**CHARTER TOWNSHIP OF VAN BUREN
PLANNING COMMISSION
March 9, 2022
MINUTES**

ITEM #1: 21-043 – APPLEBEE'S DRIVE-UP ADDITION SPECIAL LAND USE REQUEST AND SITE PLAN REVIEW.

ITEM #2: 21-004 – JSB BUILDERS LLC – FINAL SITE PLAN.

ITEM #3: 22-008 – VAN BUREN CHARTER TOWNSHIP COMMUNITY CENTER RENOVATION AND ADDITION – PRELIMINARY SITE PLAN.

Parking and Loading

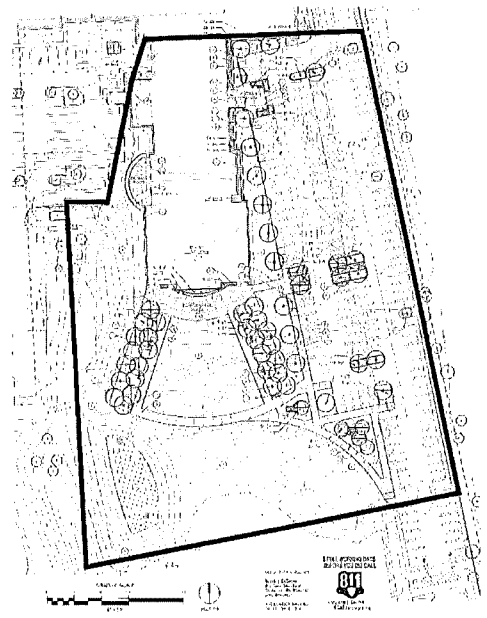
- **Space Dimensions.** Minimum parking space dimensions (20' deep, 9.5' wide) and access aisle minimum dimensions (24' wide) are adequately conveyed on the Plan.
- **Number of Parking Spaces.** The applicant lists 357 total parking spaces as being required based on the summation of 119 spaces being required for the existing public safety
